Re: El Paso Natural Gas Company, L.L.C.;
Docket No. CP24-550-000
Responses to Data Request - OEP/DG2E/Gas Branch 2

El Paso Natural Gas Company, L.L.C.
Maricopa Lateral Expansion Project, Docket No. CP24-520-000
October 24, 2024 Environmental Information Request

DRAINAGE STATEMENT FOR HAYSTACK COMPRESSOR STATION (PARCEL 800-20-027Z, YAVAPAI COUNTY, ARIZONA YAVAPAI COUNTY PERMIT NUMBER _____

Figure 6 – Unnamed Wash Floodplain Map (HEC-RAS)

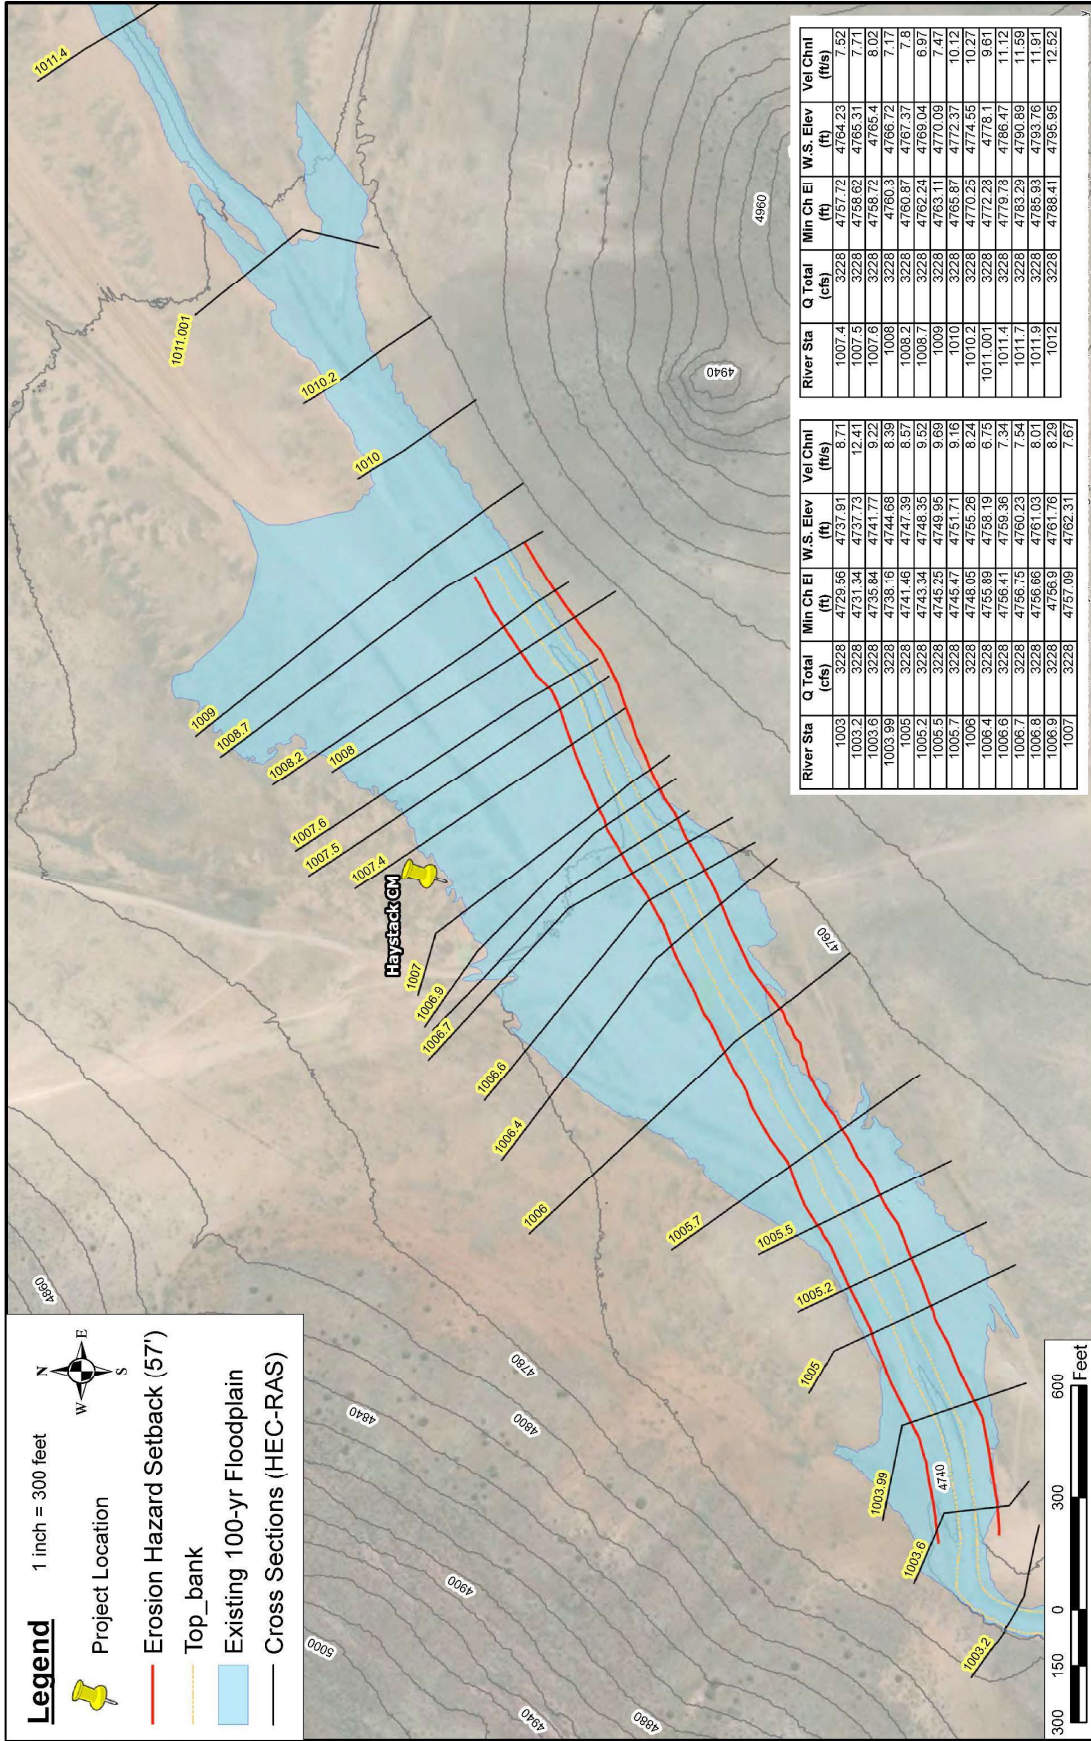
2. Section 2.2.3 states that existing access road crosses the Zone A portion of an unnamed ephemeral drainage, and a small part of the southern portion of the site and the existing access road do occur within the mapped FEMA base flood elevation. Describe any efforts to avoid, minimize, and otherwise mitigate impacts to the floodplain.

As part of the hydraulic analysis the erosion hazard setback for the watercourse located along the southern boundary of the project was determined. Based on the calculated 100-year discharge of 3390 cfs, the setback was calculated to be 57 feet using State Standard 5-96 (Arizona Department of Water Resources, 1996). The erosion hazard setback is depicted on [Figure 6](#).

View Point 6: From compressor station looking back to the nearest residence

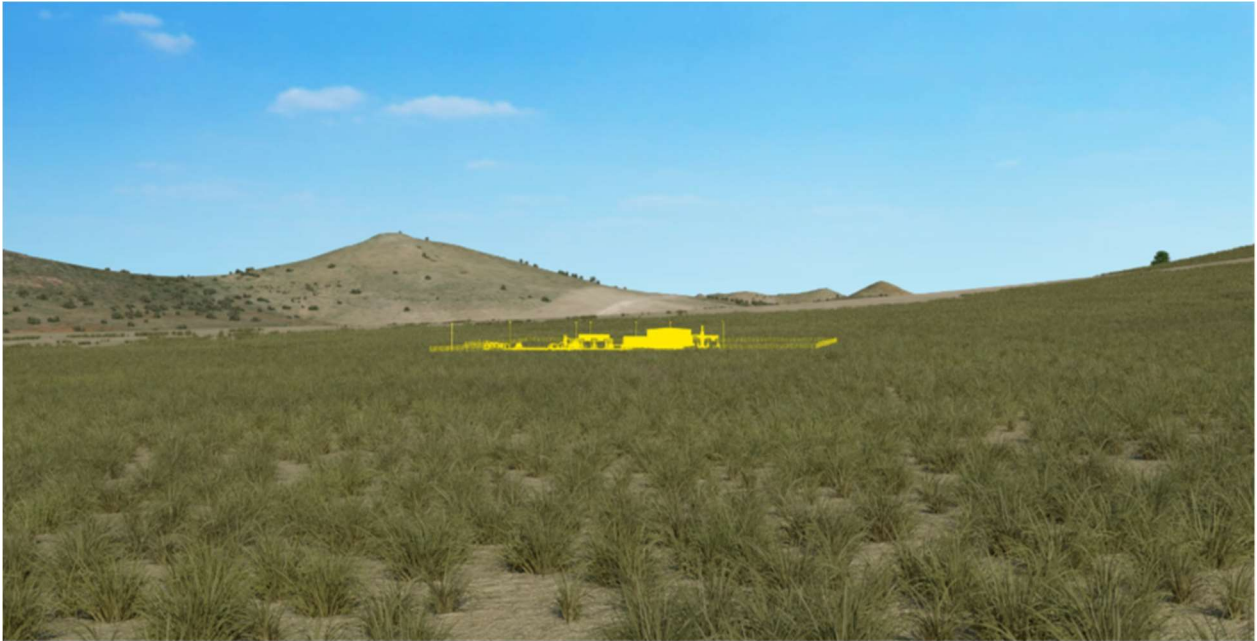
- h. Provide a visual simulation of the proposed compressor station from the nearest residences.
